Our Ref: RT/LP/JCG23770
Your Ref:

E-mail: richard.tilley@rpsgroup.com
Date: 28 March 2018

30 GLENILLA ROAD, LONDON, NW3 4AN
LETTER OF OBJECTION TO PLANNING APPLICATION REF: 2018/0932/P

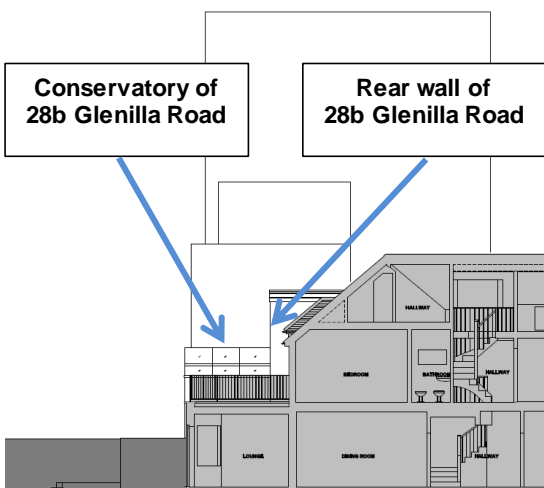
The part one, part two storey rear wing of the proposed building would have severe negative impacts on the amenity of the occupiers of 28b Glenilla Road.

The single storey element at ground level, accommodating the living/dining room of the new dwelling, would extend some 5.4m beyond the rear building line of the existing house, thus having tunnelling and enclosing effects on the windows at the ground floor of 28b Glenilla Road. The single storey element, due to its excessive depth, would also occupy a large portion of the garden, and would block or limit the views of the verdant area at the rear of the row of properties on this side of the road, to the detriment of the amenity and well-being of the occupier of No.28b.

The first storey of the rear wing would protrude from the rear building line of the existing conservatory at 28b Glenilla Road and would align with the edge of its decking (See Appendix A), contrary to the pre-application advice of the Council. The new structure would enclose the south-eastern side conservatory and create tunnelling and overbearing effects that would deprive the users of the main habitable room of 28b Glenilla Road of outlook, daylight and sunlight.

Without revisions being presented, the application should be refused on this single amenity ground. Were the applicants to submit an amended scheme that does not protrude significantly beyond the building line of the existing house at first floor level and has a reduced depth at ground floor level, we would consider the withdrawal of our objection on this point.

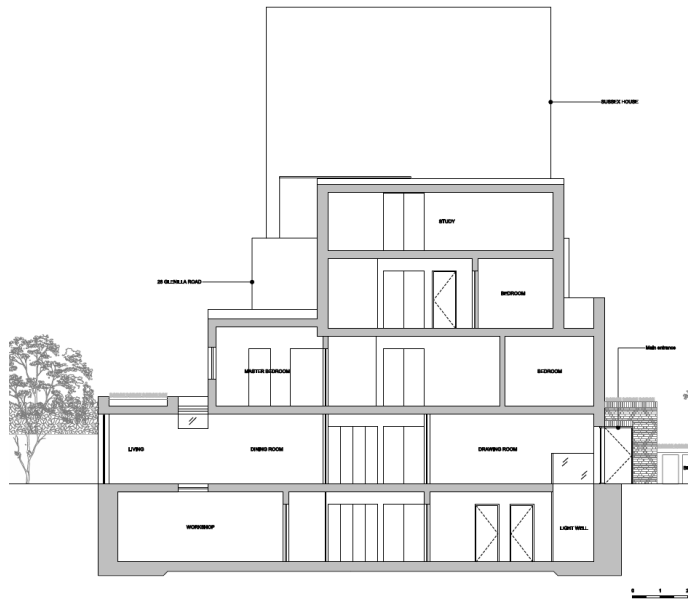
The severity of the overbearing and enclosing effects of the new building can be better appreciated by comparing the existing and the proposed sectional drawings submitted with the application. The main body of 28b Glenilla Road and the conservatory at first floor level will experience severe intrusion from the mass of the four-storey plus basement proposal.

Existing rear building lines at first floor level – From Sussex House to 40 Glenilla Road

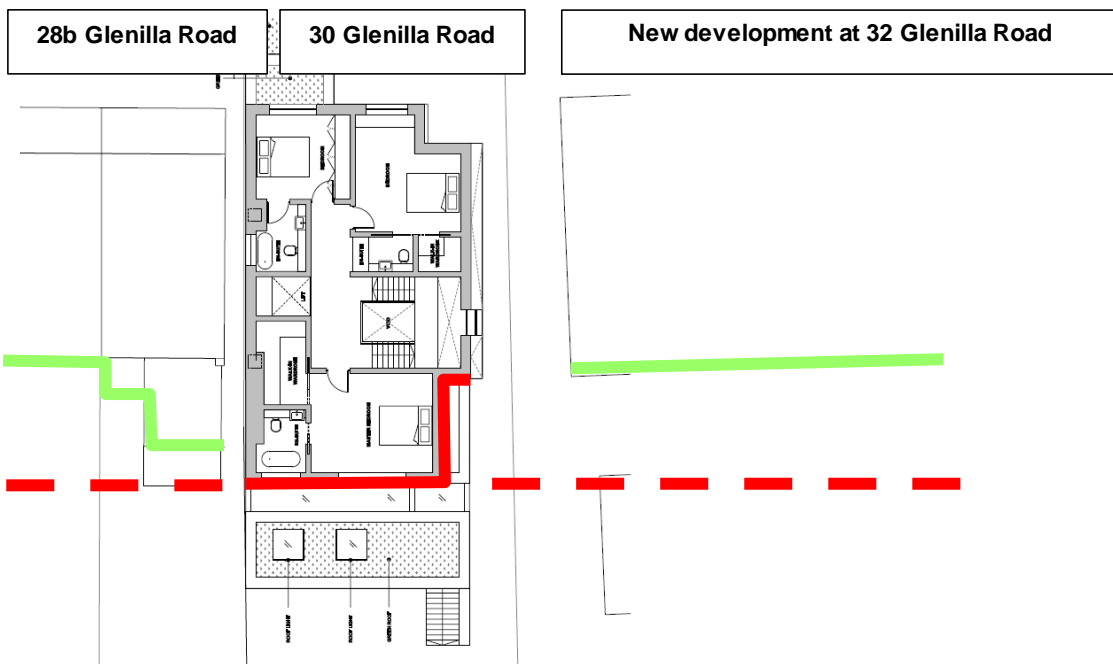
The new building would not only have negative impacts on the frontage of Glenilla Road but would also disrupt the established rear building lines of the group of buildings located between Sussex House and 40 Glenilla Road (see satellite photograph below).

The proposed development would be the first building to break the established rear first floor building lines of the area and would protrude from both the existing rear conservatory of 28b Glenilla Road and the group of buildings at Nos.36-40. Furthermore, the new building would also extend further than the proposed new development at No.32, thus becoming the only house beyond the established first floor building line stretching from the rear western corner of Sussex House to the building proposed at 32 Glenilla Road.
